## ADDENDUM No. 1

PROJECT: University Medical Center  
CV/CICU Renovation &  
NICU Renovation  
602 Indiana Avenue  
Lubbock, Texas 79415

DATE: 05/12/2025  
PROJECT NO.: 22307 & 22419

1/E2 SIXTH FLOOR PLAN - NORTH - LIGHTING  
SCALE: 1/8" = 1'-0"

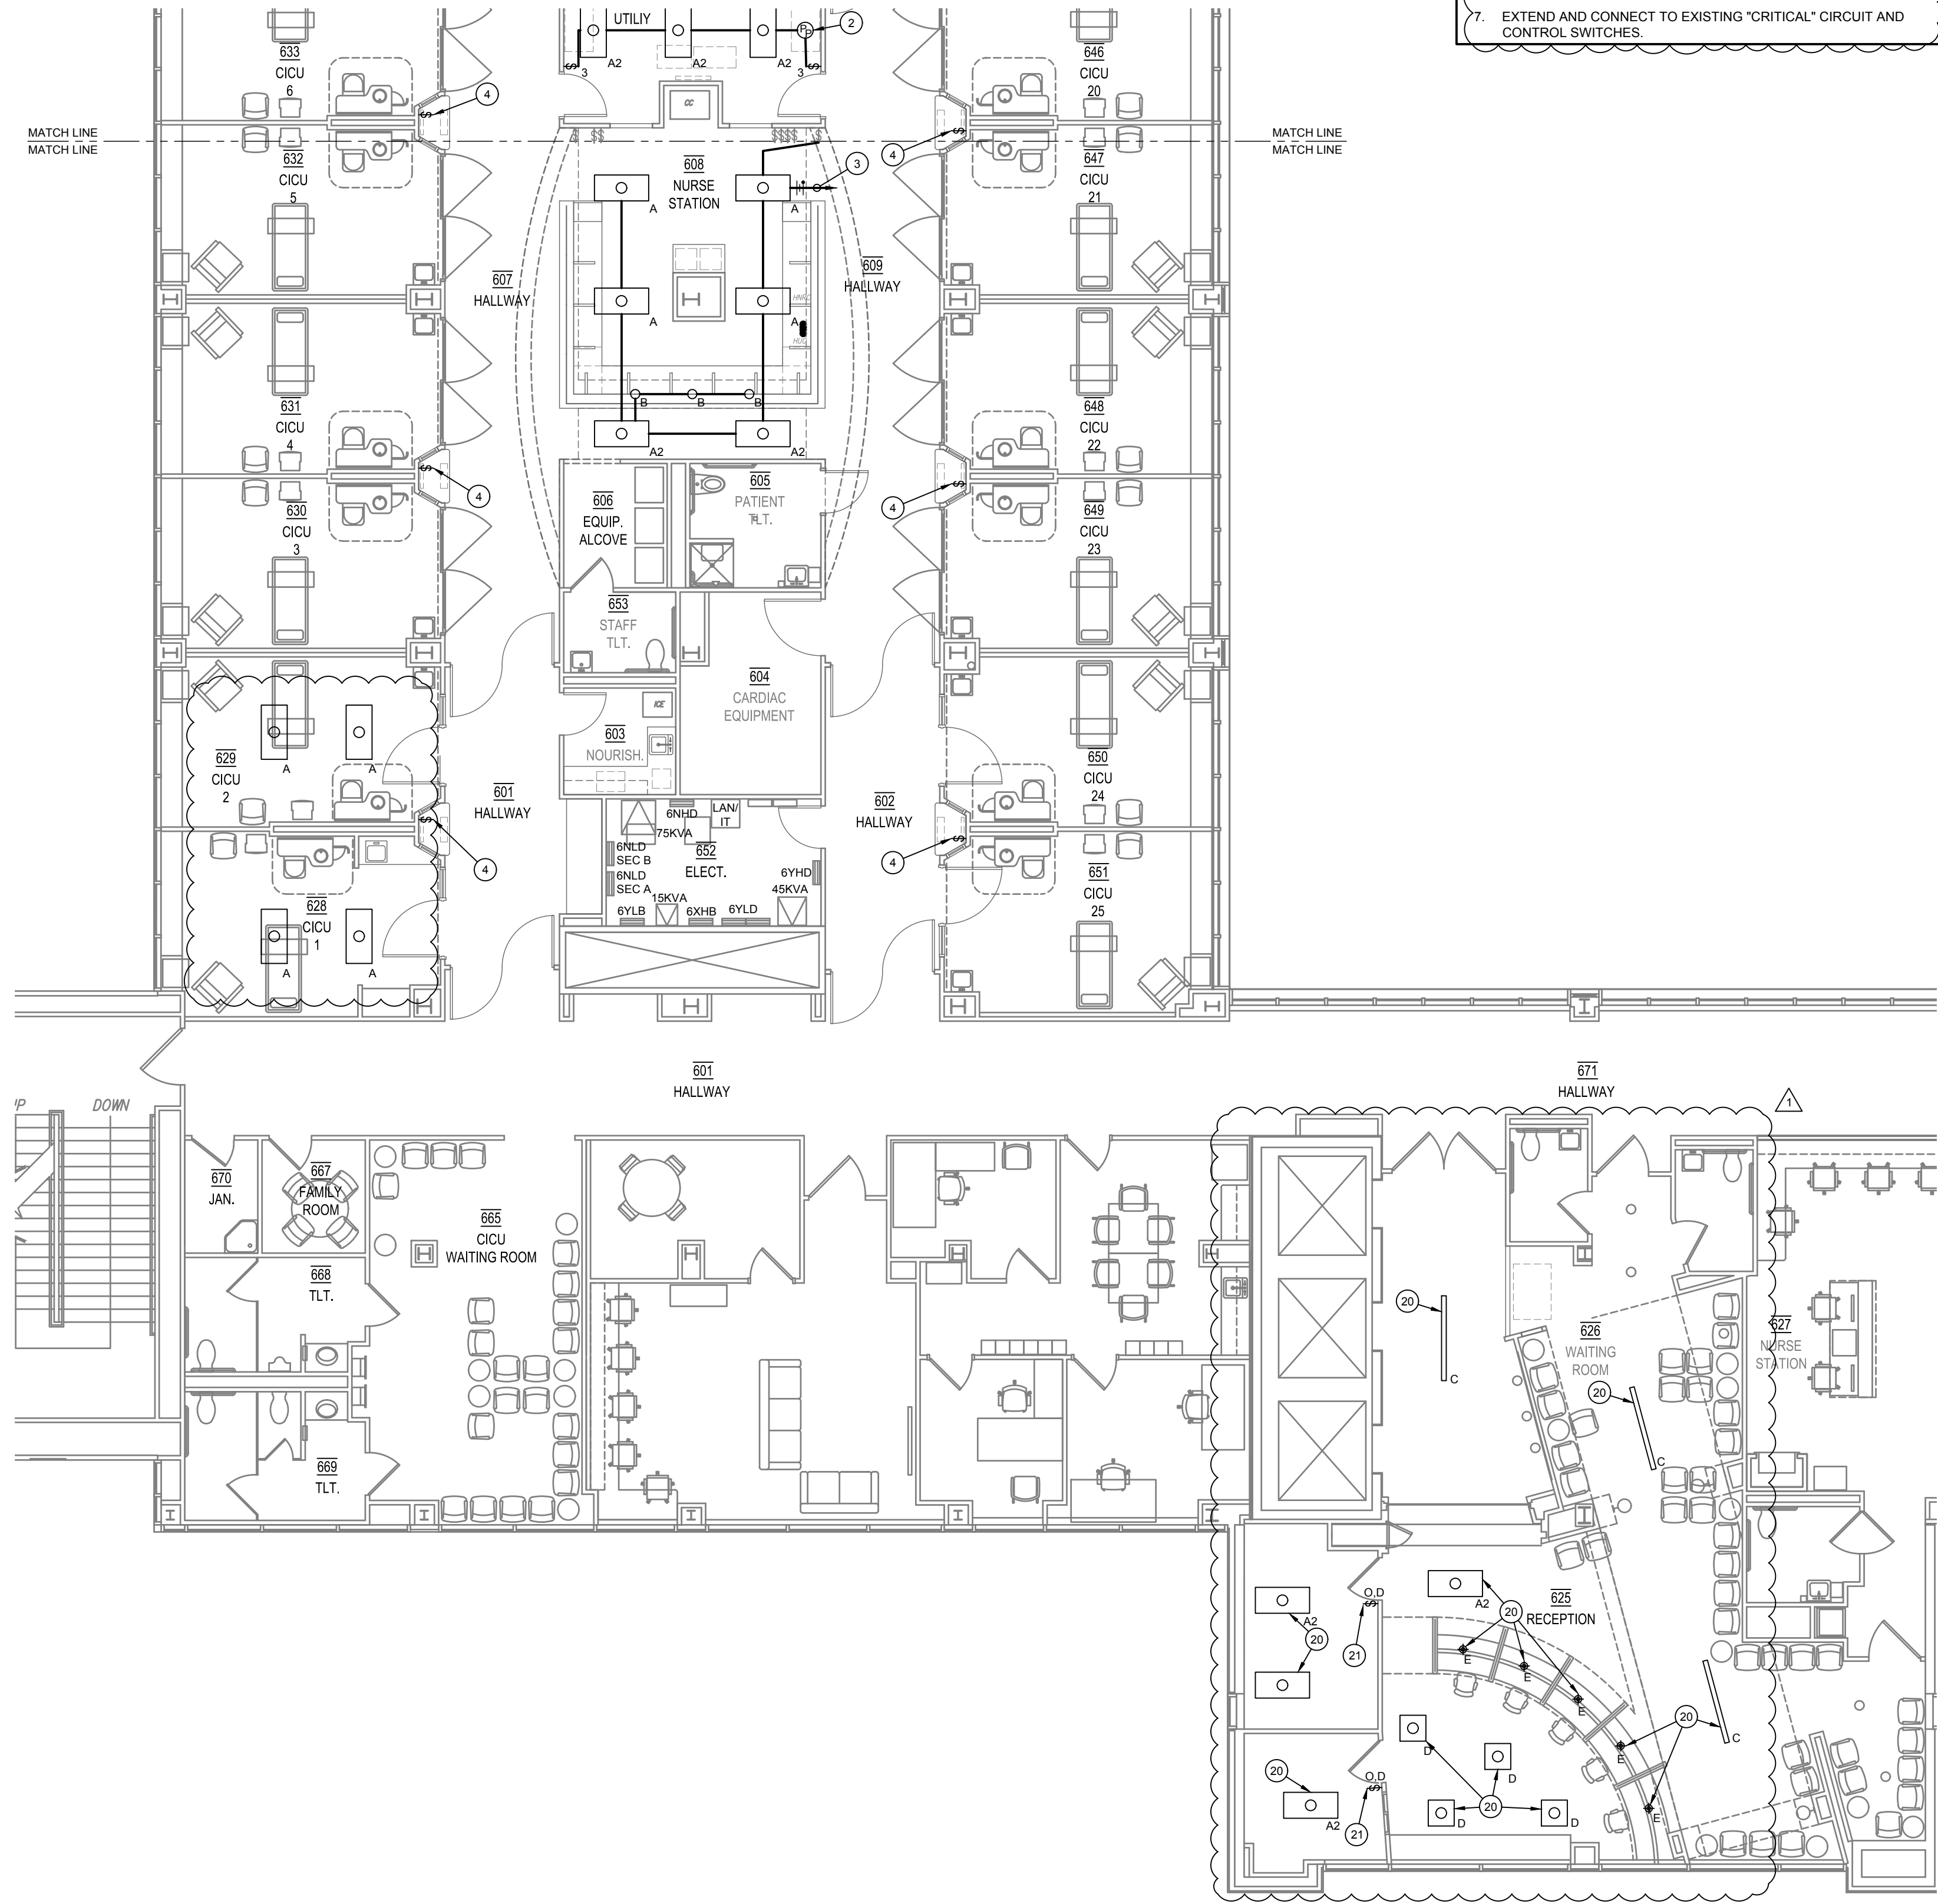
Item 2. Drawing Sheet E2:

- a. Added scope of work for alternate no.4 including light fixtures and switches in lobby area.
